Manufacturer Product Service Bulletin

Number CW03-01

Subject: Capewell Supplied Pins and Ripcords

Status: MANDATORY TEST – This is a one-time TEST. One of the two tests (either TEST 1 or TEST 2) must be performed and marked per test procedure.

Broken Ripcord Pin

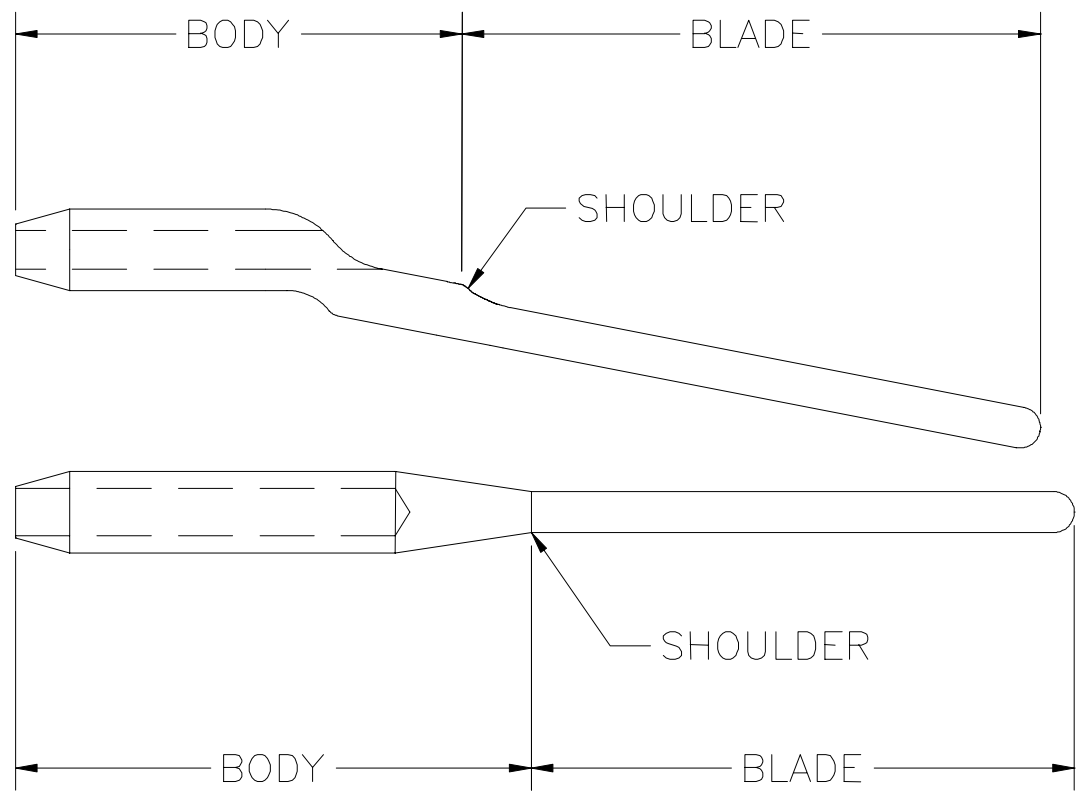
Capewell Components LLC has received (3) reports from (3) customers of (4) ripcord pins that broke. All (4) pins were reported to have broken under very low force. All (4) pins are reported to have broken on the blade section of the pin, approximately 1/8" (3 mm) from the shoulder of the pin. A broken pin is pictured below.

Affected Ripcord Pins are: MS70107 (angled), PS70107 (angled), 61C4304 (angled); 55A6480 (terminal)

WARNING: A DEFECTIVE PIN COULD CAUSE A PARACHUTE SYSTEM TO MALFUNCTION

FIGURE 1

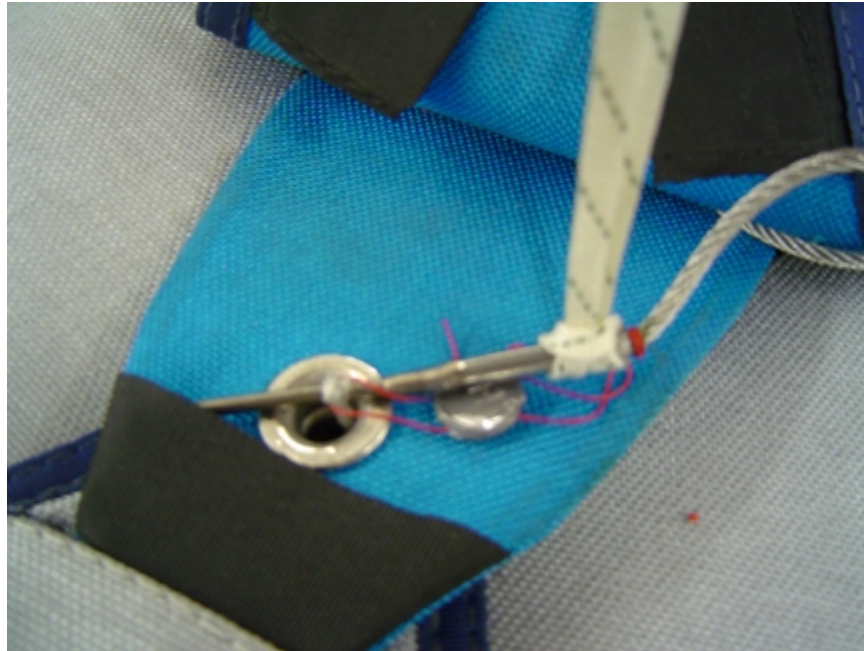
3. Take the suspension line and tie the two ends together with an overhand knot forming a loop.
4. Route the loop around the body of the pin to form a lark's head knot as close to the cable entrance end of the pin body as possible (Fig. 1).

5. Secure the other end of the loop to the spring scale.
6. Apply a load of 15 lbs. (6.8kg) straight up and 90 degrees to the axis of the pin for a period of 3 seconds and then release the load (Fig. 2). Inspect the pin for any deformation or bend. If the pin is straight, continue with step 7 below. If the pin is not straight, as visible without magnification, remove the pin/ripcorder from service immediately.

FIGURE 3
All dimension in inches

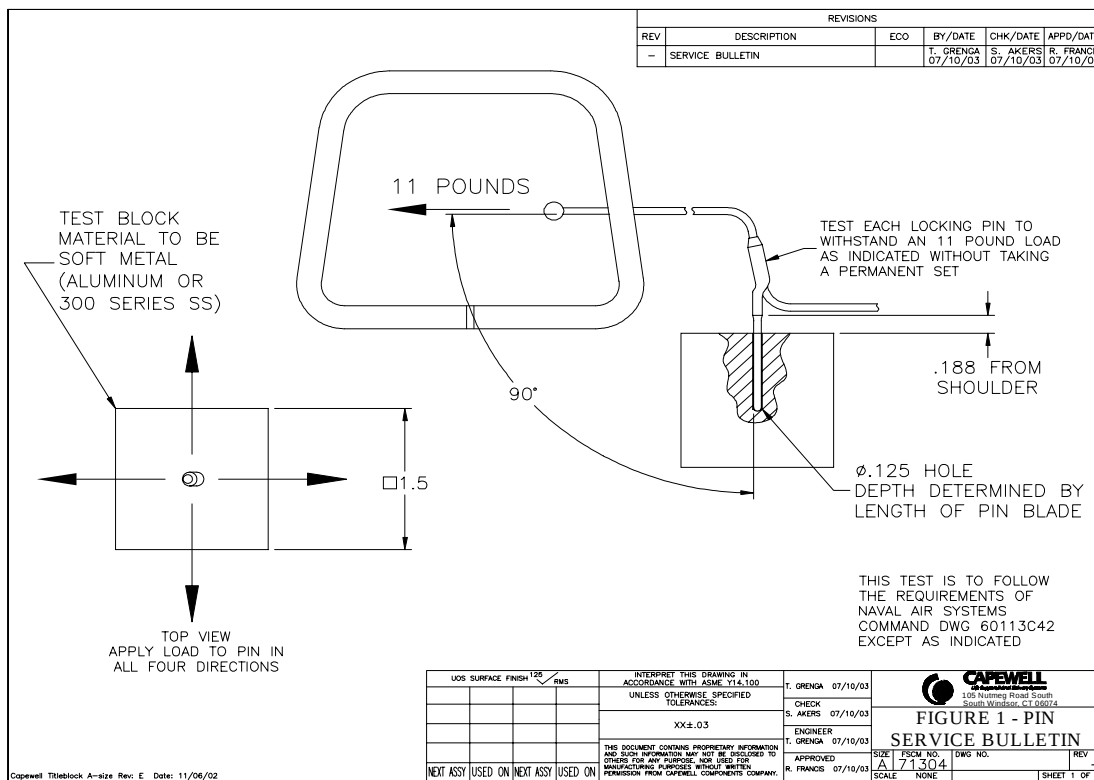
1. Place pin in test block per Figure 3 (below). NOTE: The pin block hole may be VERTICAL or HORIZONTAL
2. Apply 11 lb. force 90 degrees perpendicular to the pin blade.

3. Remove pin from block and inspect:
 - For straightness: Pins in excess of .005 (.12 mm) deformation along the blade of the pin should be removed from service.
